Planning Commission Staff Report

Meeting Date: February 28, 2022

Petition: **P.Z. 18-2021 Legends at Schoettler Pointe (Stock and Associates)**: A request for a zoning map amendment from an “E-1/2 AC” Estate One-half Acre District to a “PUD” Planned Unit Development for 9 acres located on the south side of Outer 40 Road and east side of Schoettler Road (19S640152 & 19S640657).

January 7, 2022

Figure 2: Preliminary Plan

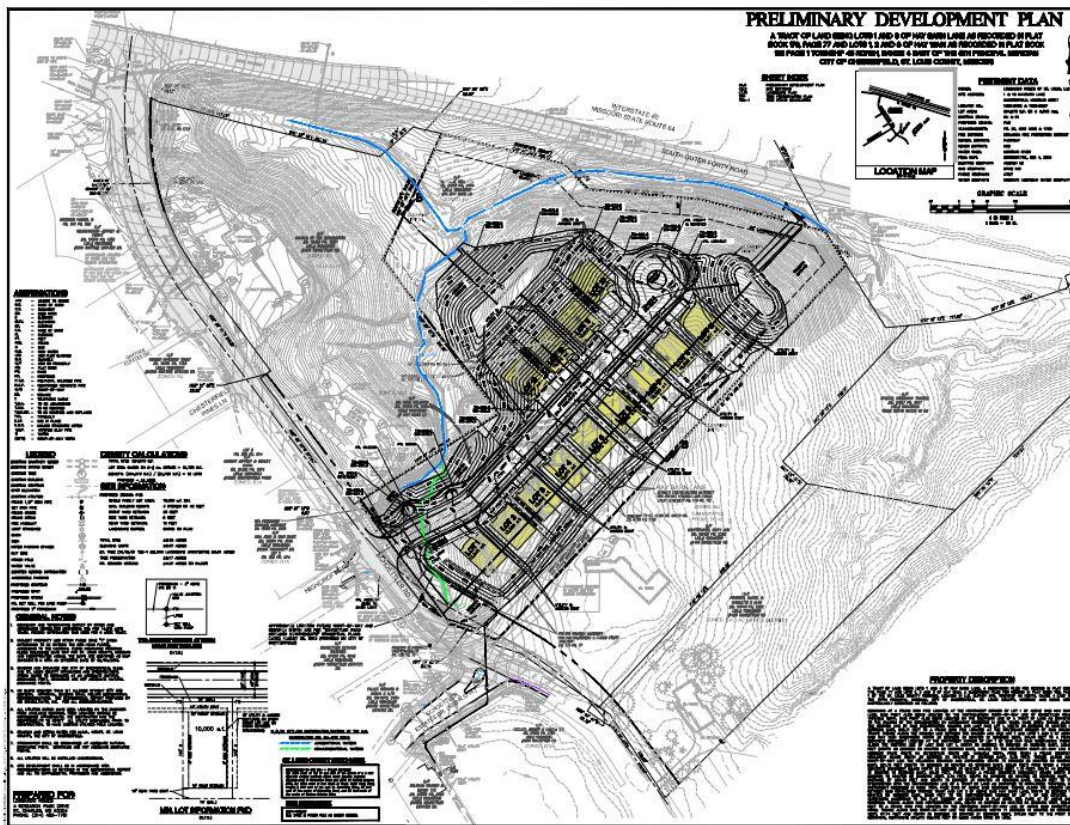
Concerns were raised regarding the side setback request. Specifically, in regard to the ability to get equipment within the setback to maintain landscape appearance. It was also discussed that the development would be under common maintenance. Please address the compatibility of a 5' setback and further describe the interaction of the common maintenance for the development.

Concerns were raised regarding the topography of the site. Specifically, discussion was held over the significant grade change on the west and north of the subject site. Provide further information on how the development team will be addressing the grade change including the height and description of any retaining walls that will be used to facilitate the development. Also identify any impacts on the adjoining property to the west.

Concerns were raised regarding the proposed amenities on the site. It was also stated by the development team that additional amenities may be provided. Provide clarification and/or description of the additional amenities and provide a response on the appropriateness on the amount of amenities in relation to the proposed development.

A discussion occurred in regards to the landscape buffer along the eastern property line. It was stated that an additional fifteen (15) foot landscape buffer will exist beyond the depicted thirty (30) foot landscape buffer. Provide additional detail on plan location, how the buffer will be established, and who will be obligated for its maintenance.

Response: Side Yard Setbacks have been increased to six (6) feet. This is consistent with the minimum permitted residential side yard setback as outlined in the City of Chesterfield's Unified Development Code.

Response: The proposed grading does not impact adjoining properties, project disturbance contained within the subject property. Site design utilizes retaining walls, varying in height from 1.0 -20.0 feet tall and limited to the northeast portions of the site, in an effort to balance the earthwork at 30,000 cubic yards and meet the City of Chesterfield's Unified Development Code standards for street grade.

Response: Legends at Schoettler Pointe will have four amenities located near the main entrance and at the cul-de-sac. The main entry will have a gazebo and couples swing, both with tiered retaining wall and ornamental plantings. A firepit with benches will be placed inside the island of the cul-de-sac. A "lookout"/pedestrian gathering space with benches, pavers, and ornamental plantings will be located along the outside of the cul-de-sac. Please refer to the Preliminary Development Plan and Landscape Plan for amenity locations.

Response: Please refer to Preliminary Development Plan for the location of the additional 15.0' buffer, buffer spans the rear of Lots 1-9. The maintenance of the additional 15.0' landscape buffer will be the responsibility of the Homeowner's Association.

SHEET NO.: C1.0

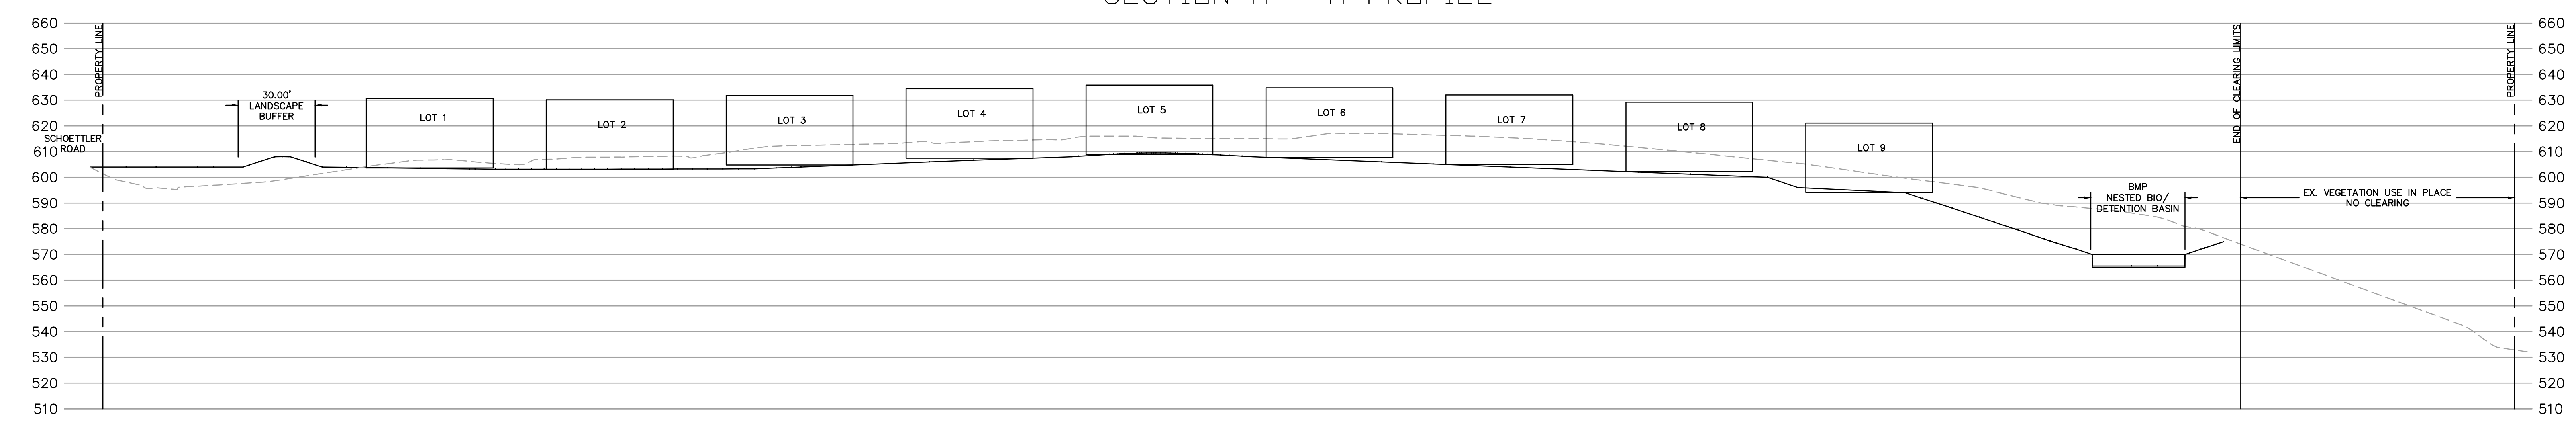
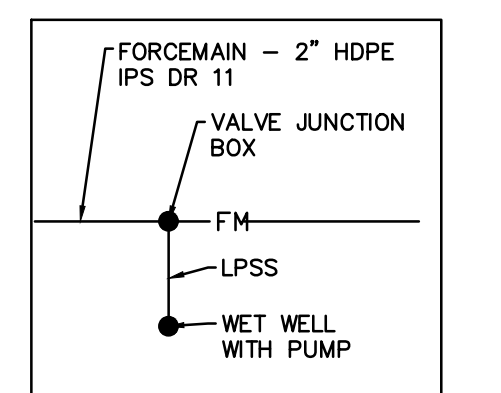
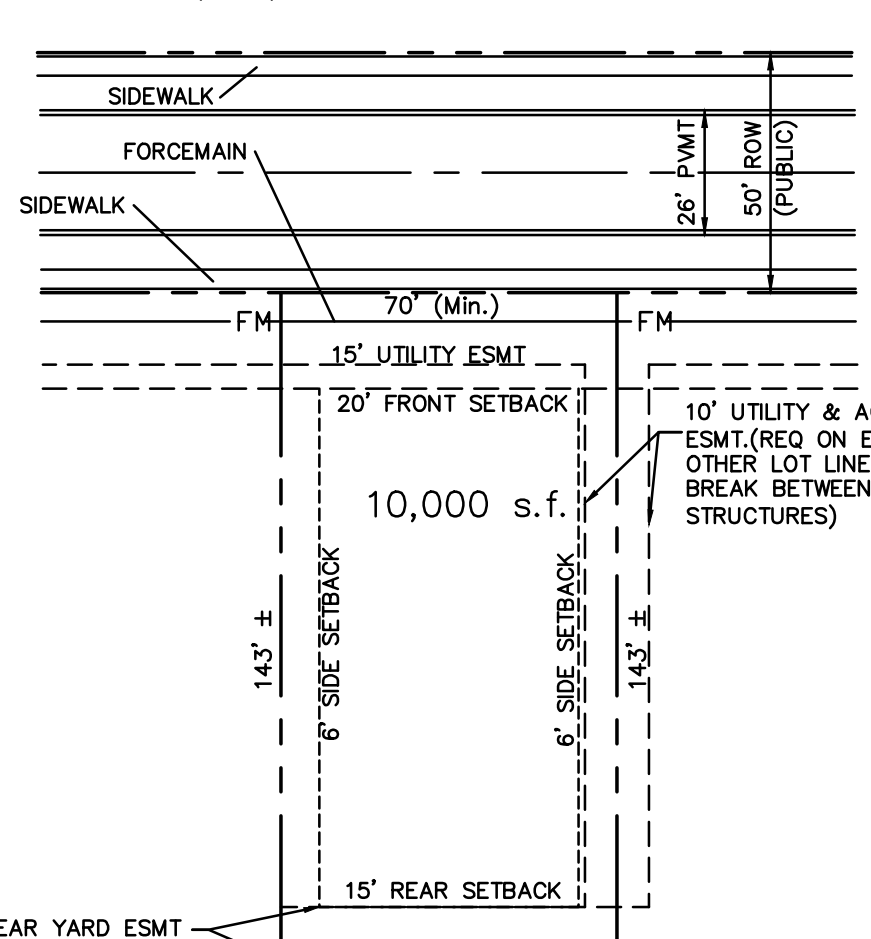
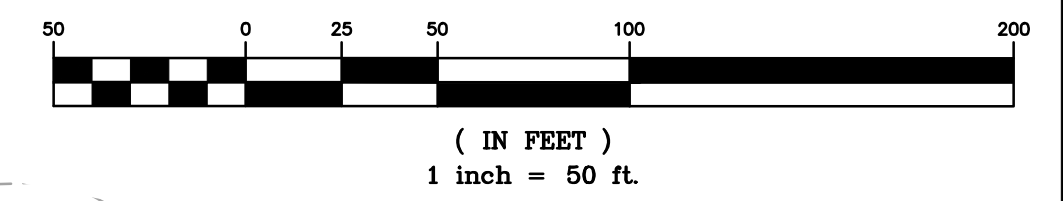
1. Please label the proposed road as a public or private street along with street width on the plan.

4. Revise the graphic scale on the Preliminary Development Plan sheet to be to scale.

1. The proposed lot layout encroaches upon the following easements as shown on the Boundary Survey: an existing 20'w Easement, 10'w Easement to Laclede Gas Co., Easement to St. Louis Co. Water Co., and a Public Utility Easement. The utilities located within said easements must be relocated around the proposed improvements. New easements encompassing the relocated utility locations must be dedicated and recorded prior to Improvement Plan approval. The existing easements must also be vacated, and the vacations must be recorded prior to Improvement Plan approval.

2. The existing Haybarn Lane private ingress/egress easement for private roadway must be vacated and recorded prior to Improvement Plan approval.

3. A site distance analysis will be required for traffic approaching from the south. Developer will be responsible for constructing the improvements to Schoettler Road necessary to provide the minimum allowable sight distance.

Response: Please see Preliminary Development Plan, Schoettler Pointe is Public, 50.0’ right-of-way & 26.0’ feet of pavement.

Response: Graphic Scale is to scale, please see Preliminary Development Plan.

Response: Understood.

Response: Understood.

Response: Understood, a site distance analysis has been included in this submittal. No improvements to Schoettler Road are necessary.

Response: Understood, a 15.0'w rear yard easement & a 10.0'w utility/access easement has been added to the Preliminary Development Plan. Please refer to the "Min. Lot Information PUD" on C1.0.

Sheet Title:	Tree Preservation Plan
Sheet No.:	TPP
Date:	10/15/21
Job #:	1043.001

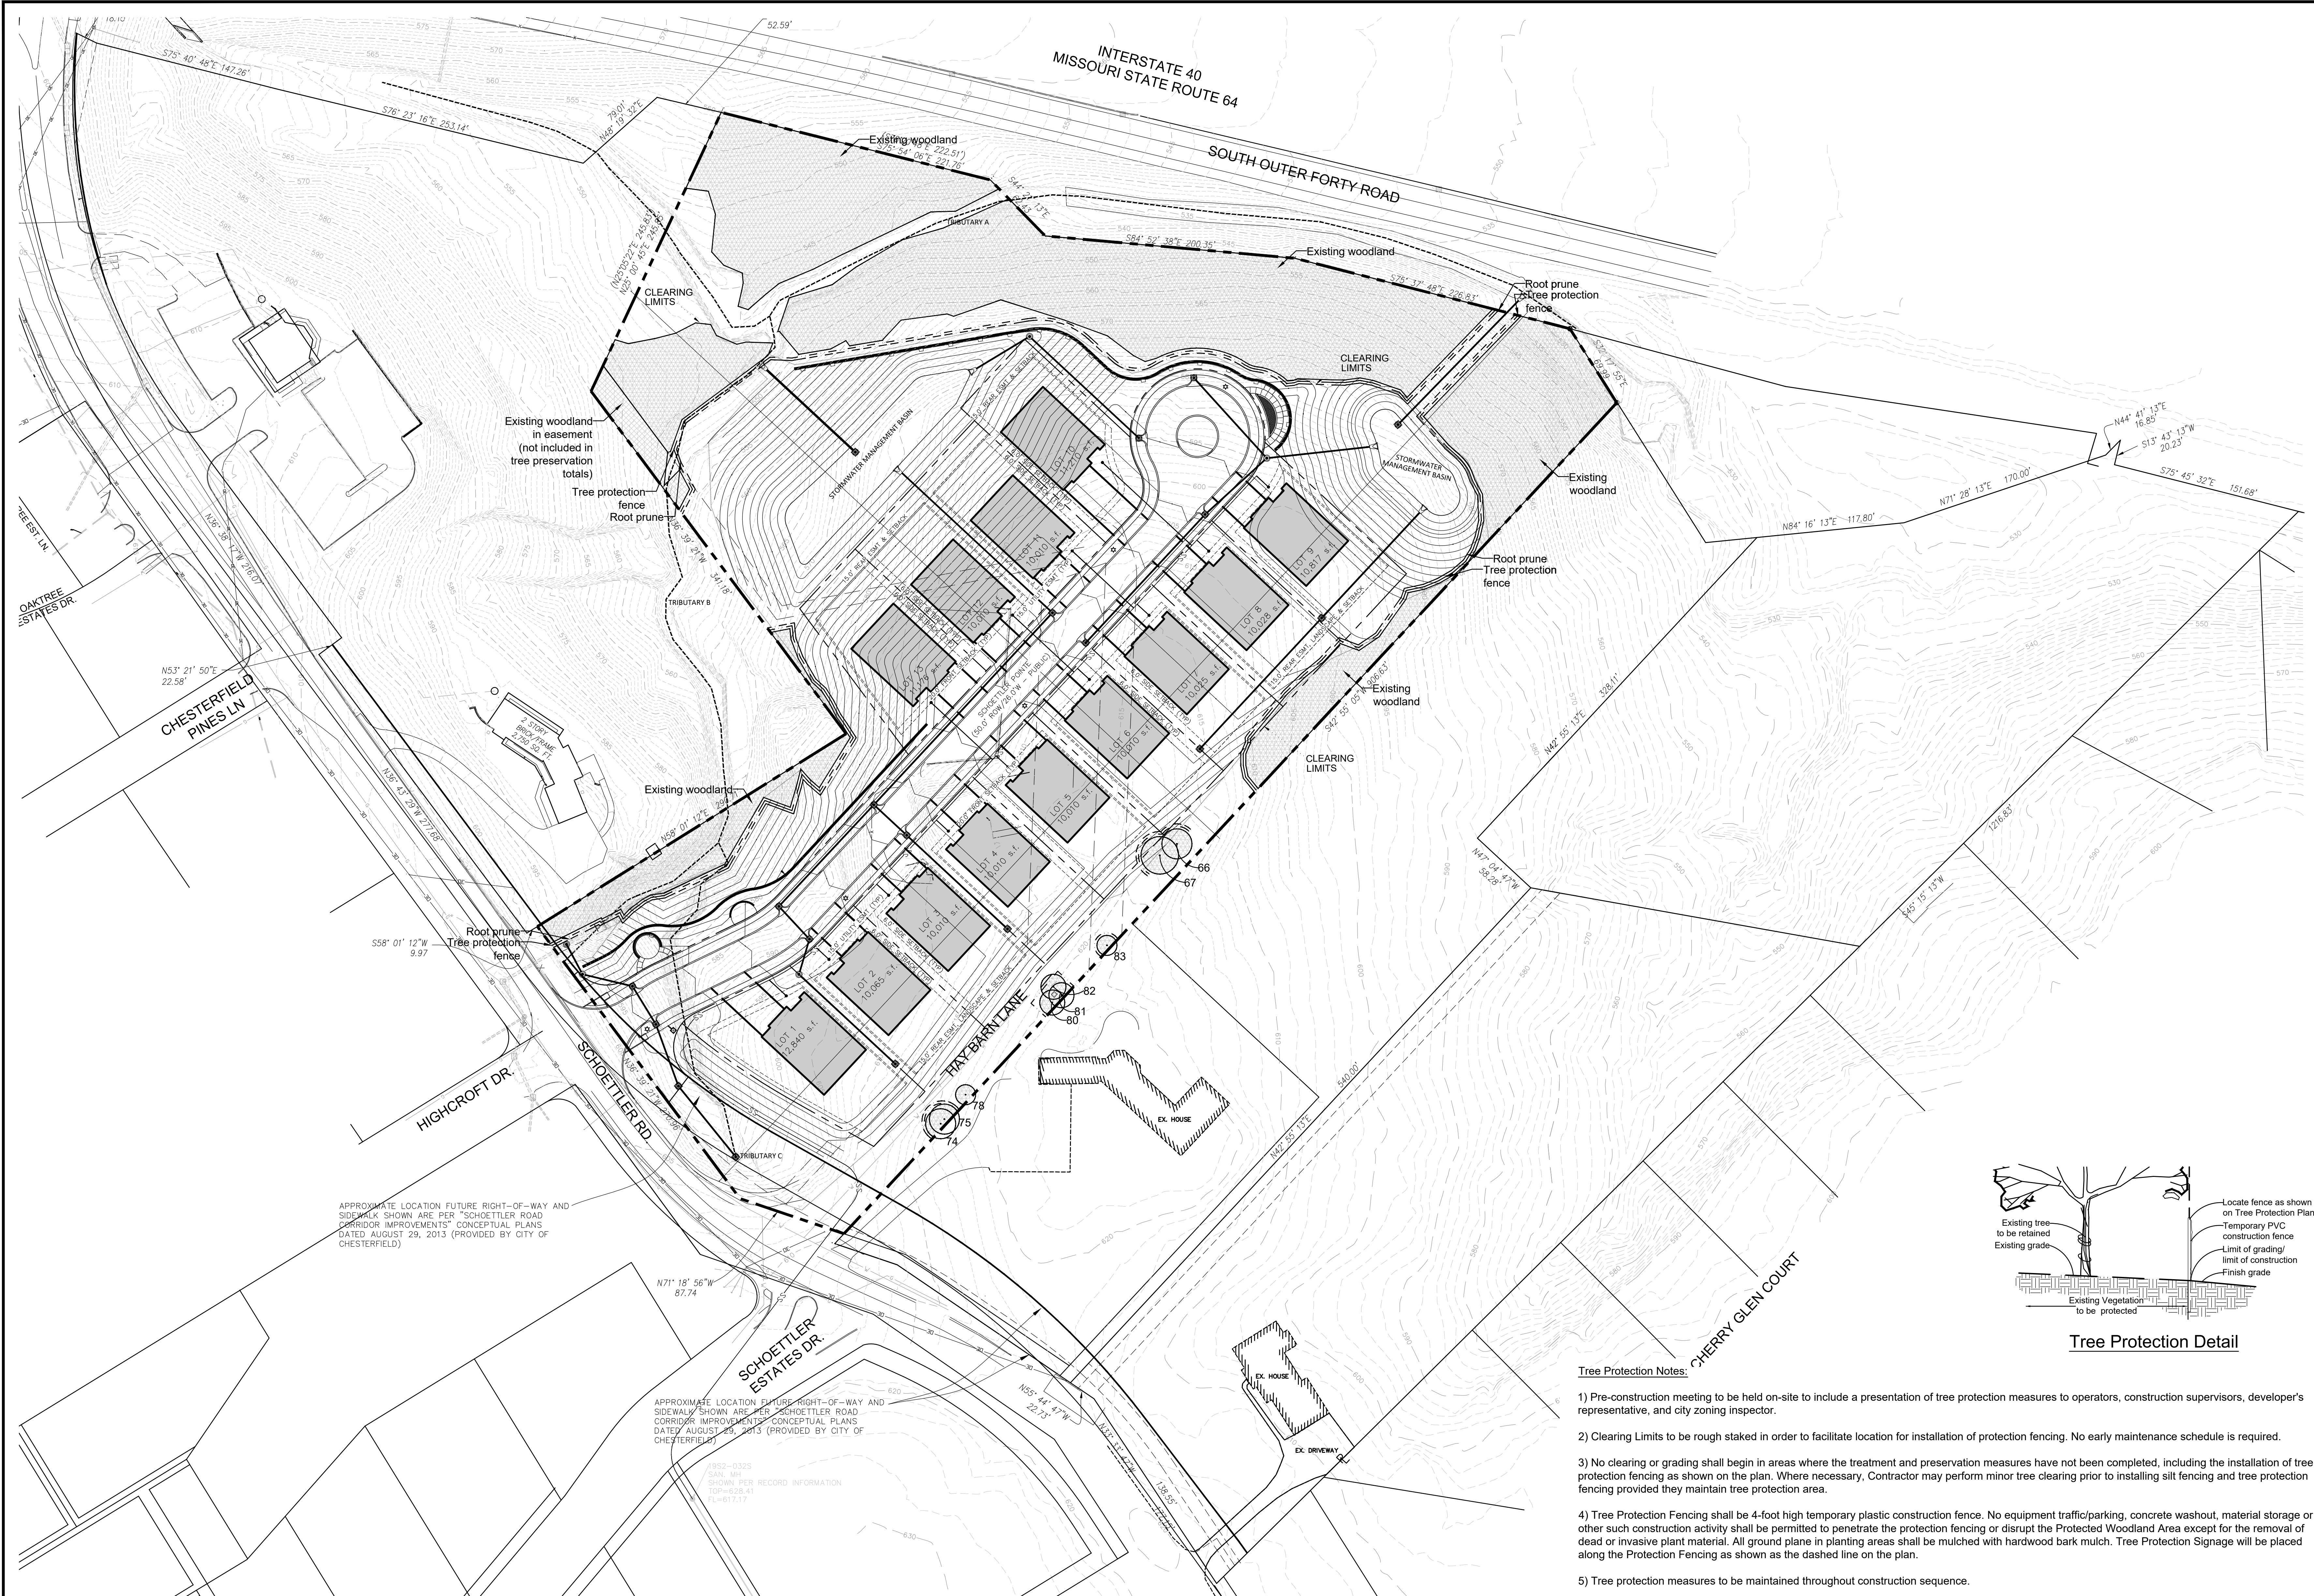
1. Provide the location, type, and size of all monarch trees as shown on the TSD and the critical root zone for those monarch trees within fifty (50) feet of the limit of disturbance.

Response: Please see Tree Stand Delineation Plan, no existing tree's meet the criteria to be classified as a monarch tree.
